SITE ELECTRICAL TECHNOLOGY SCHOOL
 FOR
 Simpson Co. CTE Improvements & Alternative School Addition
 400 S College St, Franklin, KY 42134

260115 Simpson Co CTE Tennis Court RR Bldg Hardware Changes
 January 15th, 2026

FACPAC Contract Change Order Supplemental Information Form (Ref# 64968)

Cost associated with PR 004.

U1.1

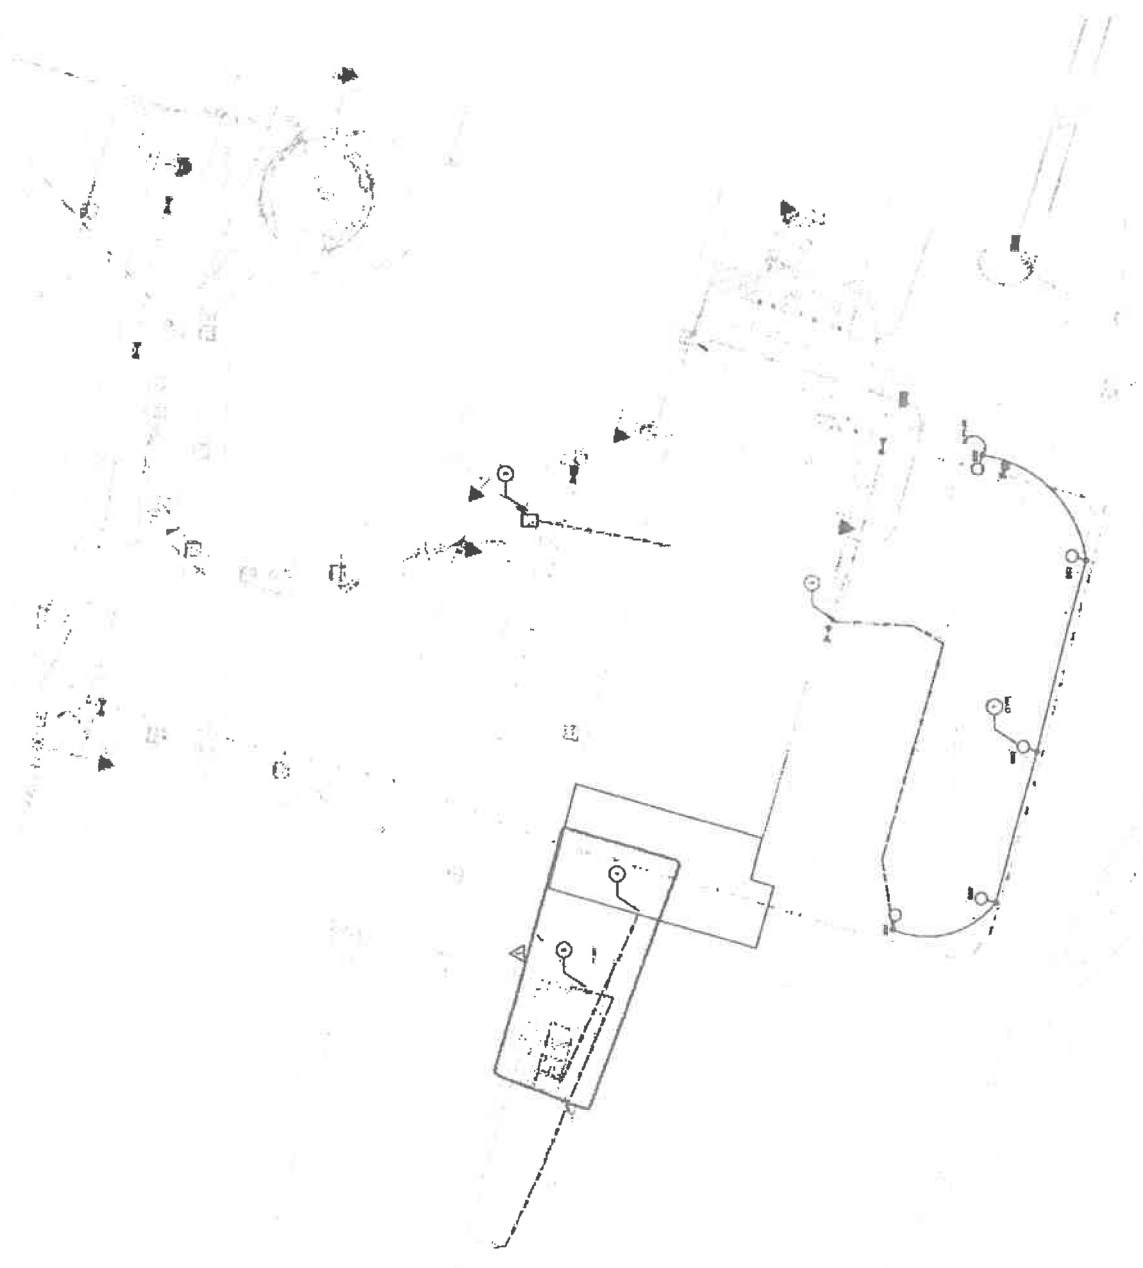
ELECTRICAL CONSTRUCTION TAG NOTES
 APPLIES TO THIS DRAWING ONLY:
